Name: Ptarmigan Ridge – North – 27.5 Rd. / Cortland – Final Plan

TITLE HEADING: Final Plan/Plat - Ptarmigan Ridge
North

FILE NO. 119-93, FINAL PLAT & PLAN - PTARMIGAN RIDGE NORTH

FINAL PLAT

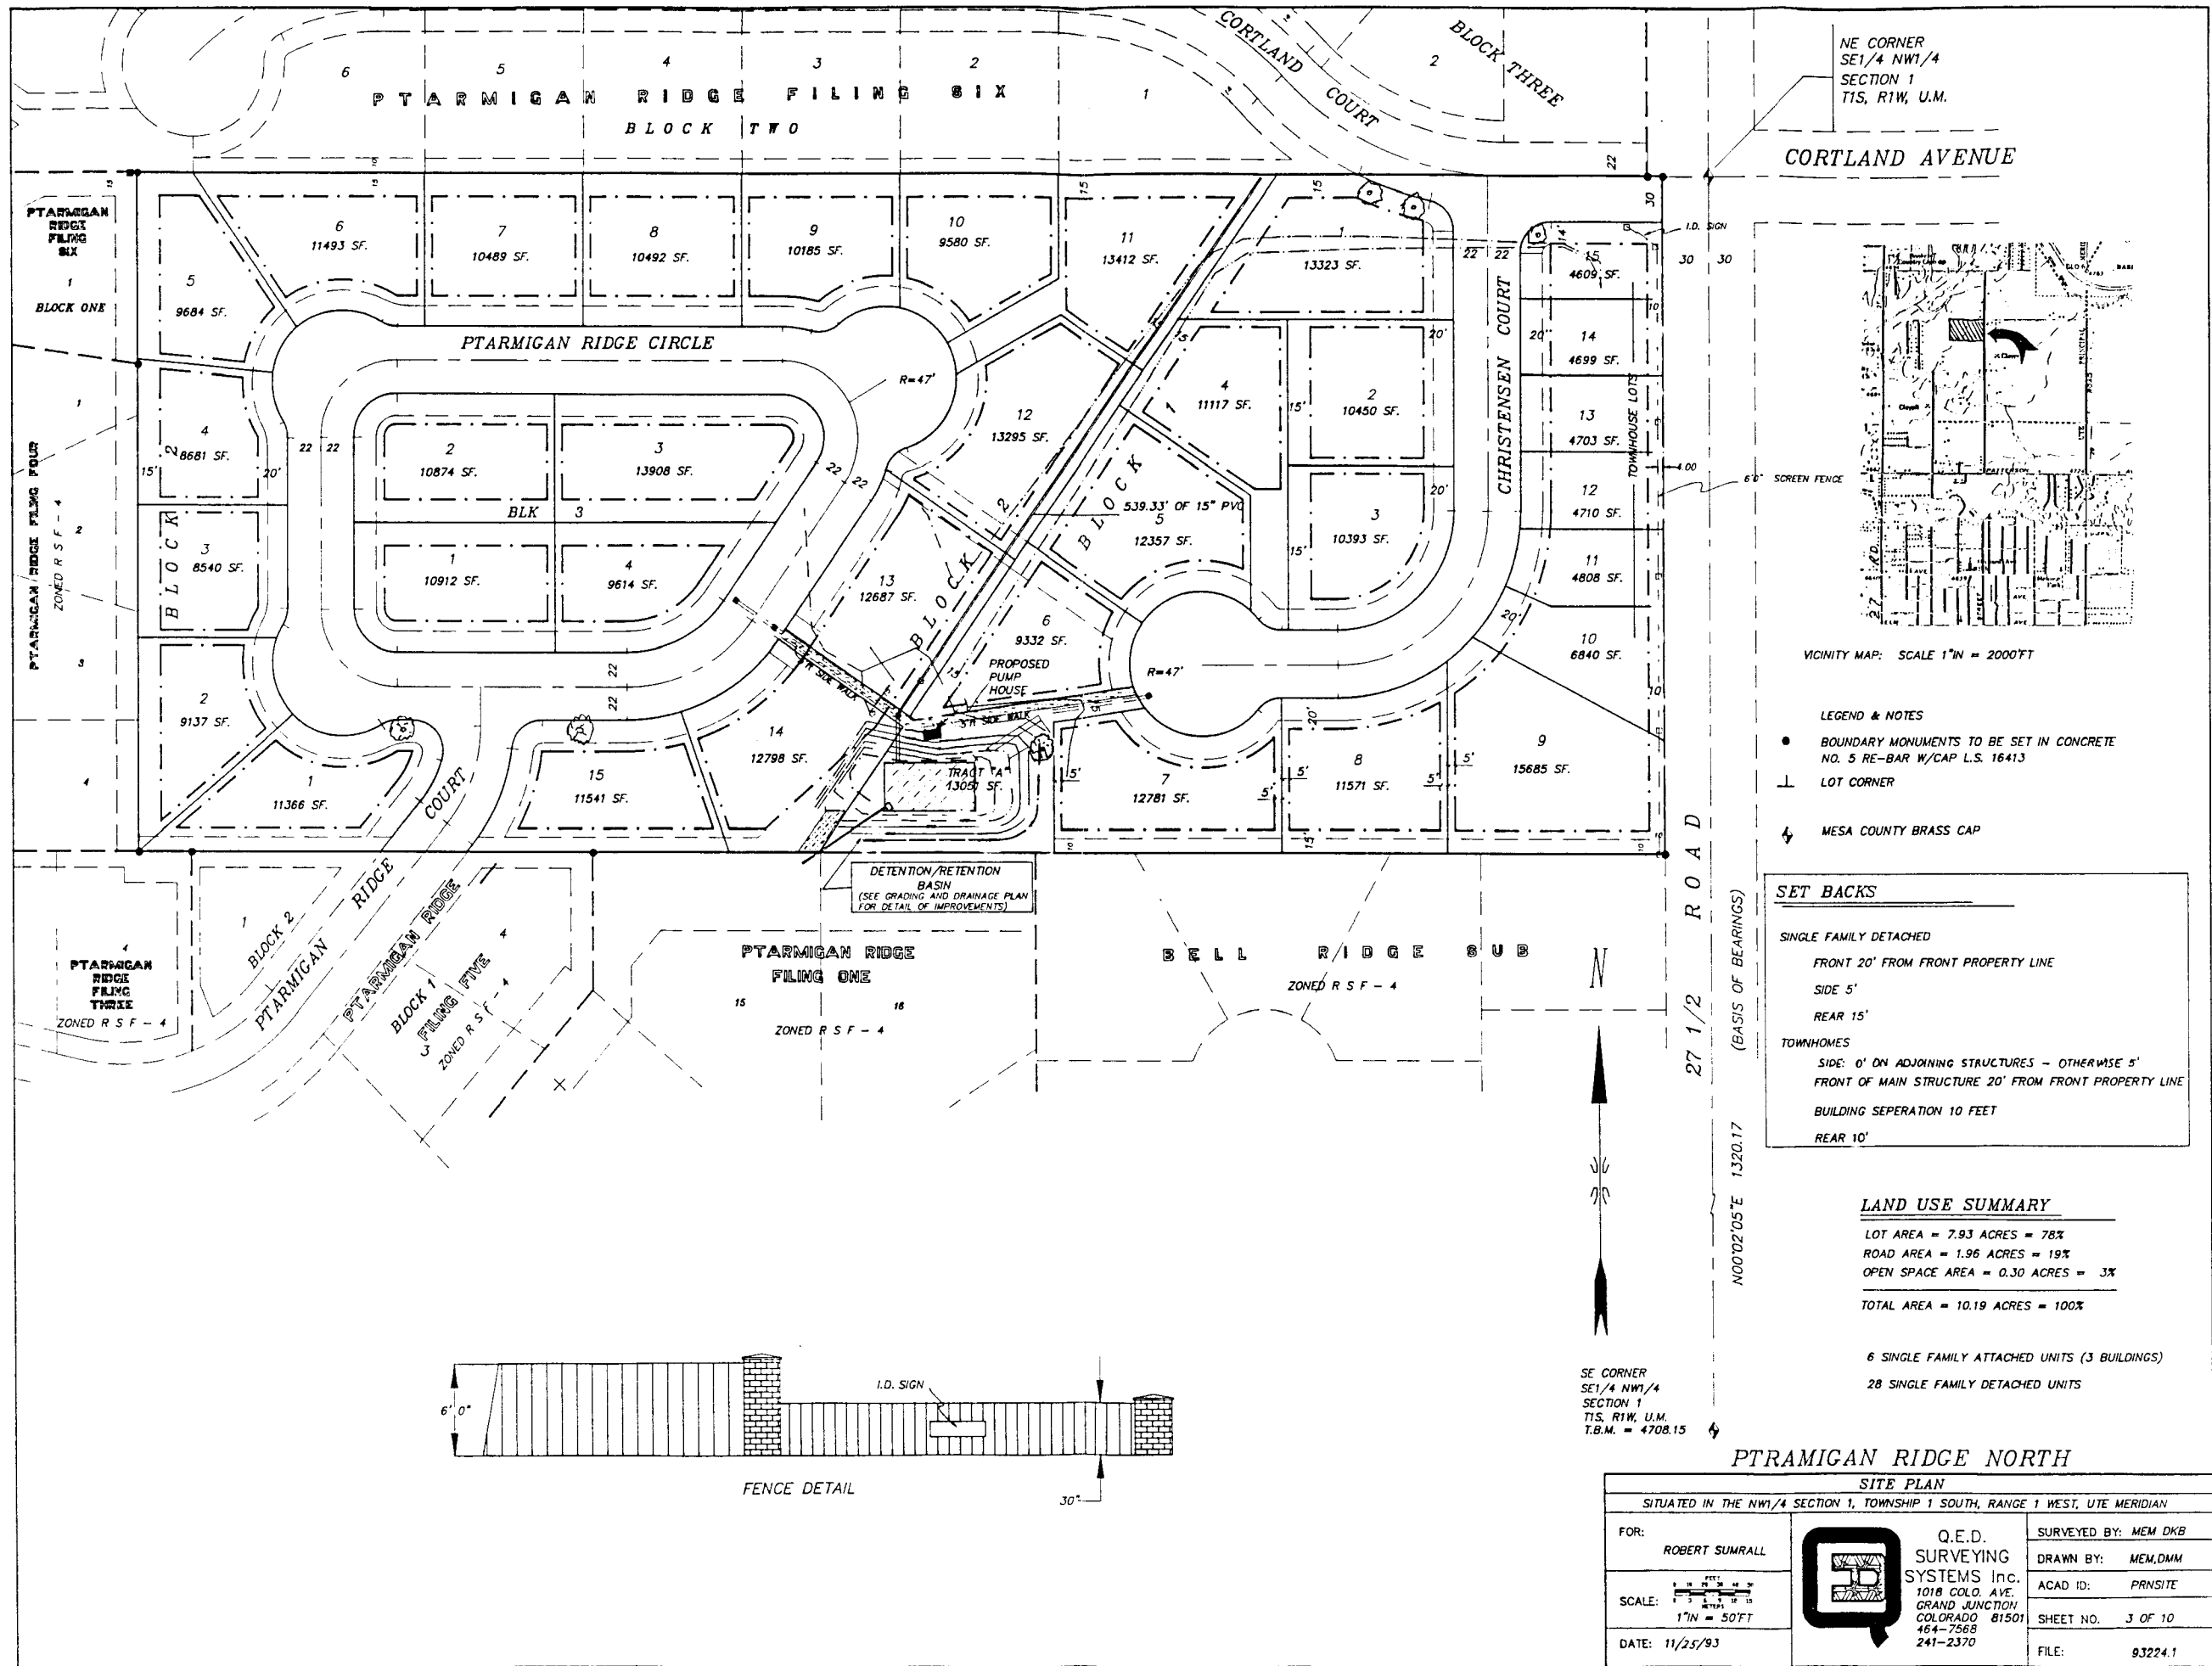
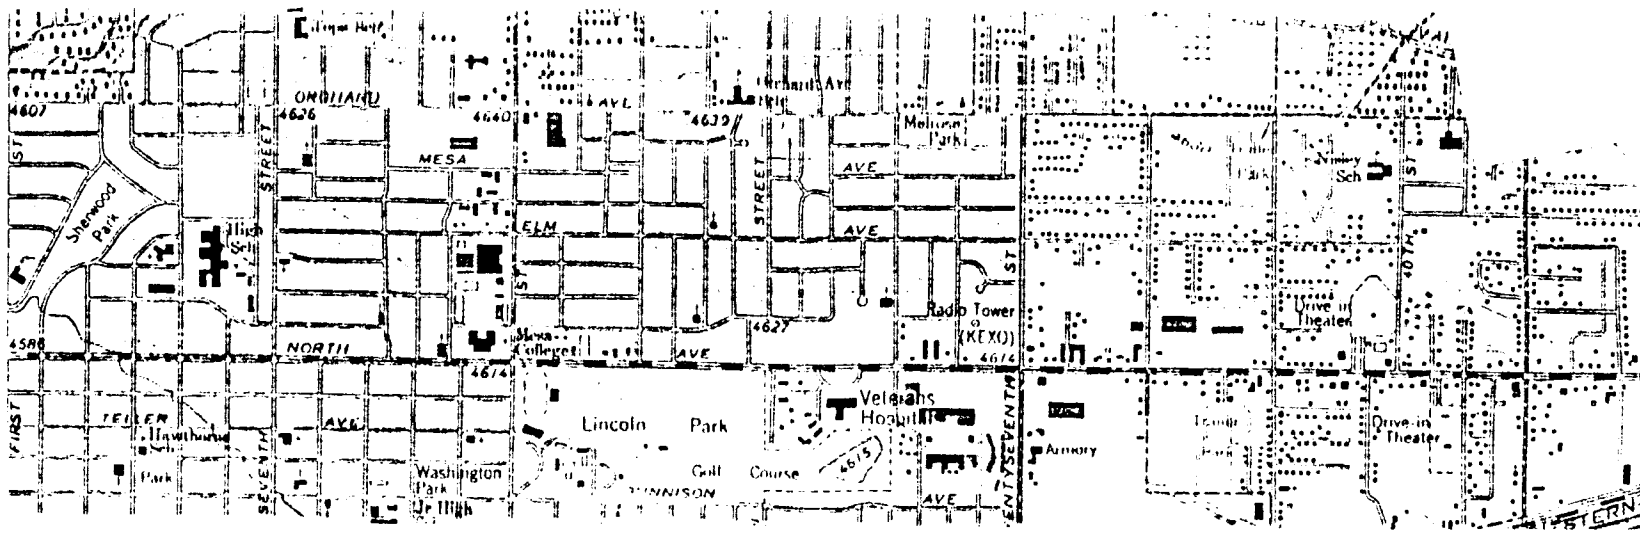
~~No planting of trees or shrubs shall be allowed within ~~the~~ this tract.~~

* Remove "OR FENCES" ~~_____~~

Remove →

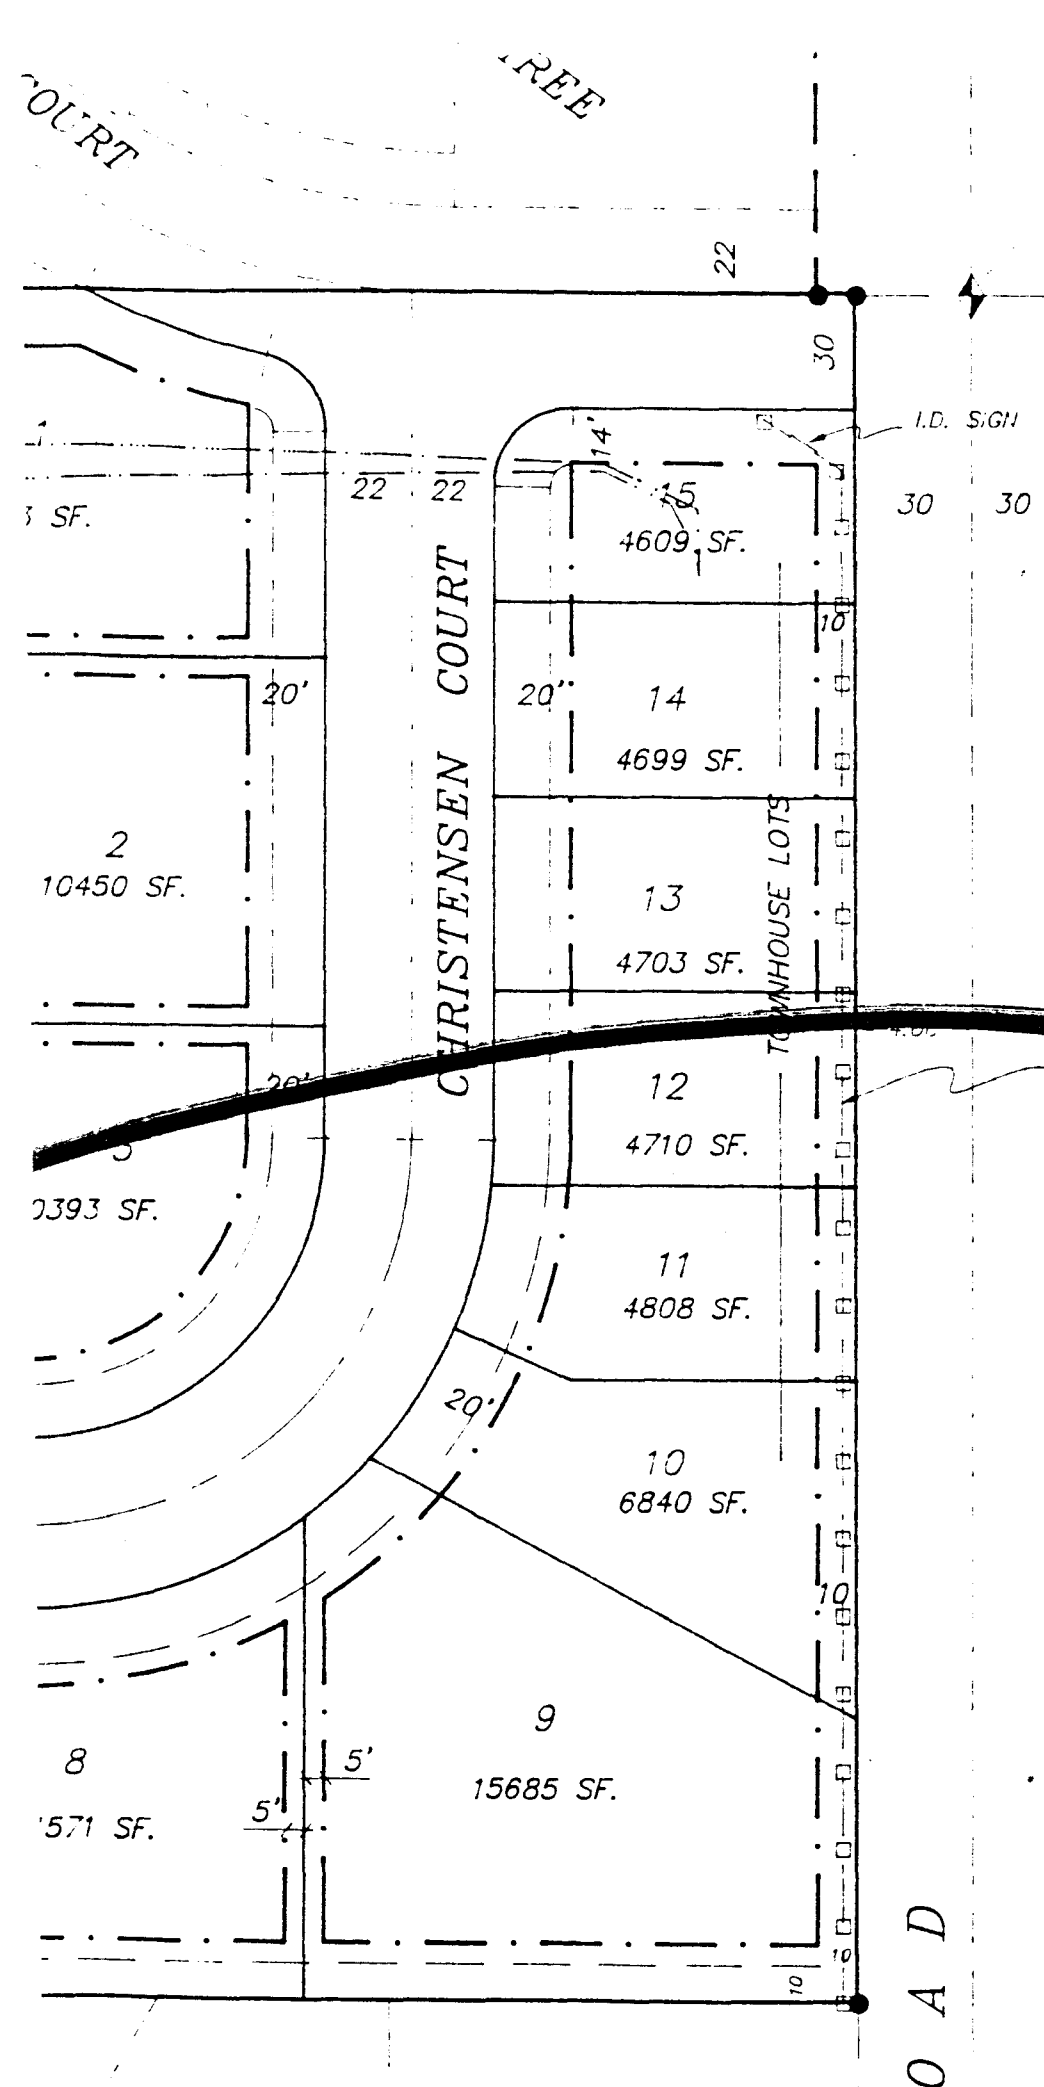
Why is this being built in the neighboring property's easement? Shouldn't this area also be a part of Tract "A" with language allowing the pump house as the only approved structure in Tract "A".
